**STAFF REPORT**  
**(Preliminary Plat)**

**CASE NUMBER:** S/D 96-60 - NORTHRIDGE ESTATES ADDITION

**STAFF REPORT**  
(Final Plat, Preliminary Plat Approved 9/5/96)

**STAFF REPORT**

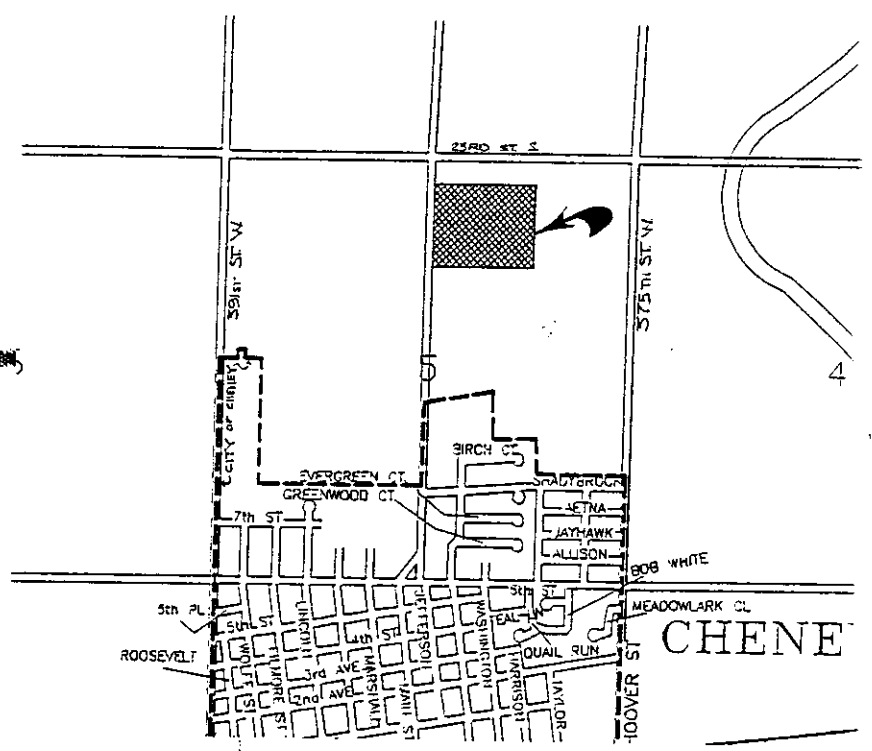
However, the Health Department needs to comment if certain of the lots have sufficient area, free of floodway, to provide for a home and septic system. Specifically, Lots 2, 3, 4 and 5 have usable areas of only from 24,000 sq. ft. to approximately 30,000 sq. ft. While lots of 40,000 sq. ft. are required for the use of septic and well systems; and these "lots" exceed that size limit, as noted "usable" areas are well under that size limit for several of the lots. If necessary, several lots may need to be combined so as to provide sufficient usable areas.

- A guarantee shall, therefore, be provided to close the opening shown at the southwest corner of Lot 7.
- E. The applicant shall guarantee any drainage improvements required by the platting of this property.

- J. On the final plat, the street Northridge shall be renamed as a "Circle" and not a Court.
- K. The 40-foot ingress and egress easement along the west line of Lot 6, if created by separate instrument, needs to have indicated the recording information for the easement on the plat. Unless this easement is for a public purpose, its creation (as a private type easement) through platting is not appropriate.

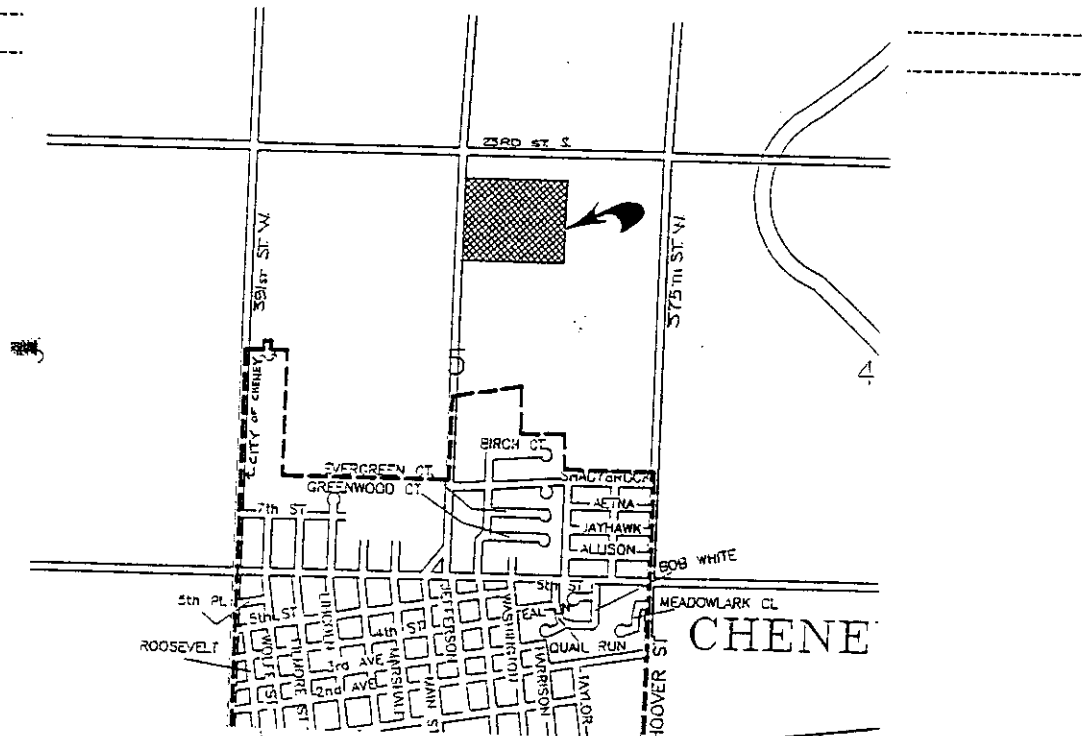
However, this final plat is continuing to show an access opening to 383rd Street West from Lot 7. At this time, apparently, an existing use on what is being platted as Lot 6, has driveway access out to 383rd Street West. Also, a use to the south appears to be using this opening for access. The plat is indicating a 40-foot easement to the interior cul-de-sac, which would apparently be to the benefit of the use south of the site. Also, the uses on Lot 6 would be expected to use the interior street when it is constructed. Consequently, the opening to 383rd Street West, appears to be a temporary need until such time as the interior street is constructed.

It is recommended, therefore, that the opening from Lot 7 only be allowed as temporary access. That a contingent dedication of complete access control by separate instrument be

provided and that words to that effect be placed in the plat's text. The contingency itself stating that complete access control to 383rd Street West from Lot 7 will occur when 383rd Street West Ct. is constructed.

- E. The applicant shall guarantee any drainage improvements required by the platting of this property.
- F. The 40-foot ingress and egress easement along the west line of Lot 6, if created by separate instrument, needs to have indicated the recording information for the easement on the plat. Unless this easement is for a public purpose, its creation (as a private type easement) through platting is not appropriate.

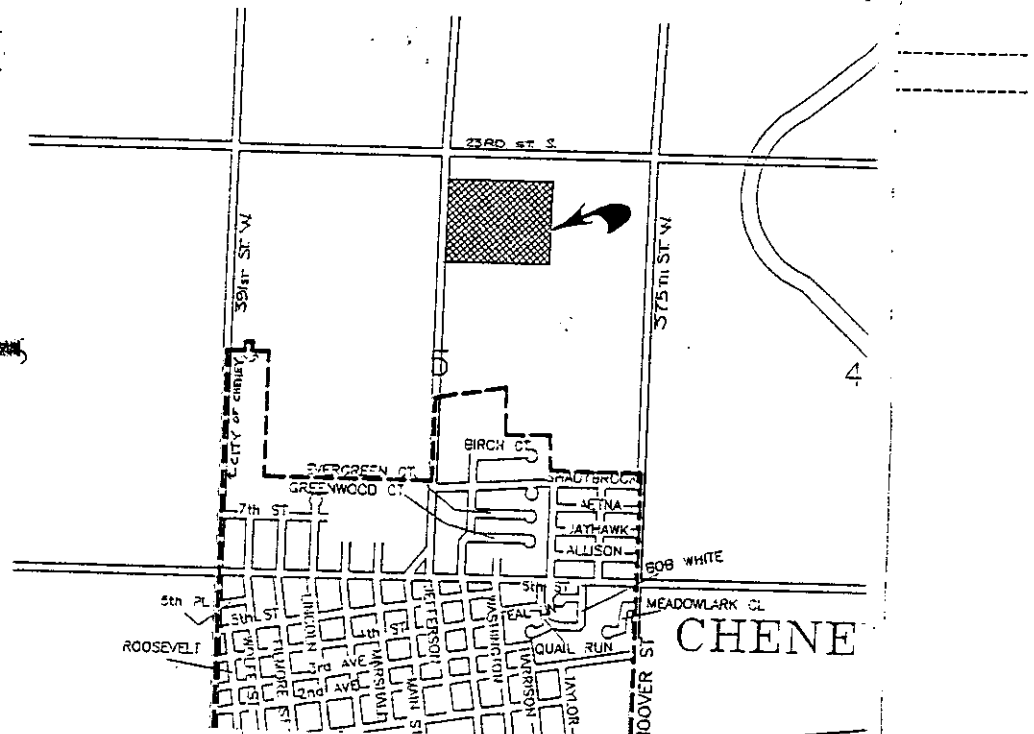
As was noted by the Subdivision Committee, this plat needs to address concerns with the limited space actually available for the location of a home, associated facilities and on-site sanitary sewer and wells on a number of the lots. Further, Lot 7 does not appear buildable by itself at this time and should be combined with Lot 8 as one (1) building site for the time being.

However, this final plat is continuing to show an access opening to 383rd Street West from Lot 7. At this time, apparently, an existing use on what is being platted as Lot 6, has driveway

access out to 383rd Street West. Also, a use to the south appears to be using this opening for access. The plat is indicating a 40-foot easement to the interior cul-de-sac, which would apparently be to the benefit of the use south of the site. Also, the uses on Lot 6 would be expected to use the interior street when it is constructed. Consequently, the opening to 383rd Street West, appears to be a temporary need until such time as the interior street is constructed.

It is recommended, therefore, that the opening from Lot 7 only be allowed as temporary access. That a contingent dedication of complete access control by separate instrument be provided and that words to that effect be placed in the plat's text. The contingency itself stating that complete access control to 383rd Street West from Lot 7 will occur when 383rd Street West Ct. is constructed.

As noted by County Engineering during the Subdivision Meeting of November 7, 1996, the term "Easement" needs to be deleted from the area shown as a "Floodway Reserve" on the face of the plat. Also, the plattor's text shall be amended to delete reference to an easement when associated with the Floodway Reserve. Further, Lots 3, 4, 5 and 6 shall indicate a minimum building pad elevation of 1364'.
